Access Compliance Report

Public Rights-of-Way

(Curb Ramps)

Intersection ID: 15279	Main Street: COLVILLE_RD	Cross Street: S_DOTGER_AV	Location: E
ADA ID: D82094267521	Ramp Type: PerpDiag	Initial Pass/Fail: Fail	Overall Compliance: No
			Severity Score: 33.75

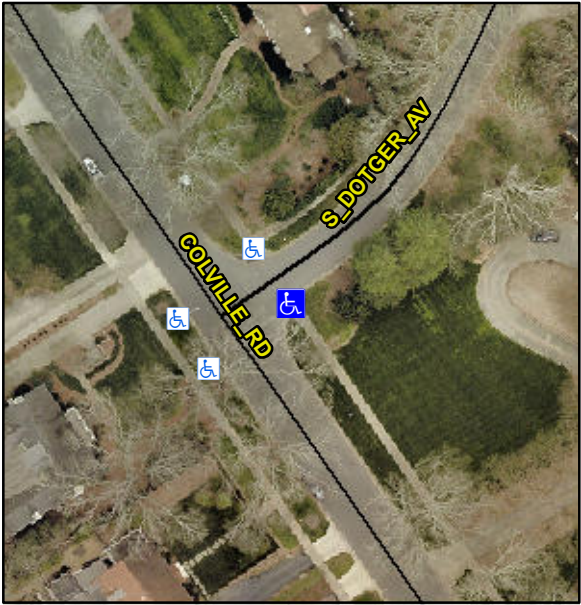
Codes/Mitigation Info/Possible Solution			Field Measurements/Component Compliance			
	Possible Solutions:		Compliance	Description	Data	Compliance
	Remove & Replace Curb Ramp With Two New Directional Ramps or Equivalent.		Description			Description
			Data			Data
			N/A	Ramp Length (in)	120.0	No
			No	Ramp Width (in)	40.0	No
			N/A	Flare Type LT	N/A	N/A
			N/A	Flare Slope LT (%)	N/A	N/A
			N/A	Flare Traversable LT?	N/A	N/A
			N/A	Landing Length (in)	N/A	N/A
			N/A	Landing Width (in)	N/A	N/A
<p>Surveyor Notes:</p> <p>N/A</p> <p>PROW/ADA:</p> <p>Not Found, R304.5.1, R304.2.2, R304.5.3</p>			N/A	Flare Type RT	N/A	N/A
			N/A	Flare Slope RT (%)	N/A	N/A
			N/A	Flare Traversable RT?	N/A	N/A
			N/A	DWS Provided?	N/A	N/A
			N/A	DWS Contrast?	N/A	N/A
			N/A	DWS Length (in)	N/A	N/A
			N/A	DWS Full Width?	N/A	N/A
			N/A	DWS Offset (in)	N/A	N/A
			N/A	Gutter Ponding?	N/A	N/A
			N/A	Gutter Lip Ht (in)	N/A	N/A
			N/A	Painted X Walk1?	No	N/A

X Walk 1 Direction	To NW	X Walk 2 Direction
			N/A	X Walk 1 Width (in)	N/A	N/A
				X Walk 1 Slope (%)	3.7	X Walk 2 Slope (%)
				X Walk 1 X Slope (%)	1.0	X Walk 2 X Slope (%)
			N/A	Ramp inside XWalk1?	N/A	N/A
				Road Slope (%)	1.9	N/A
				Road X Slope (%)	3.5	N/A
			N/A	Any Obstructions?	N/A	N/A
				Obstruction Type		Storm Grate/Utility Hazard?
Total Cost: \$ 3200.00						Storm Grate/Utility Type
					N/A	N/A
					Yes	Surface Condition? (G/P)
						Good
